# SB, New software rev. P (X-halt), PP70, 2024-09

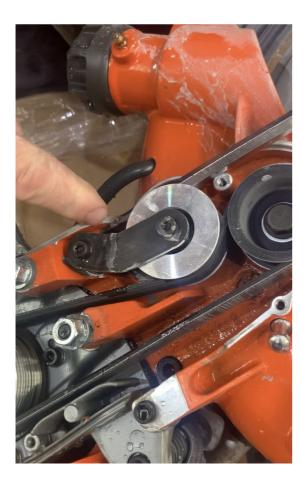
If X-halt engages incorrectly, make sure the belt tension is correct. For the K7000 16" standard cutter, see image below for correct belt tension.

For K7000 RING, use a bar or your thumb to push the belt tensioner to remove the belt slack. Tighten the belt tensioner screw to 10-12 Nm (7-9 lbf.ft). If the belt touches the chassis, the belt is too long. Replace with new belt.
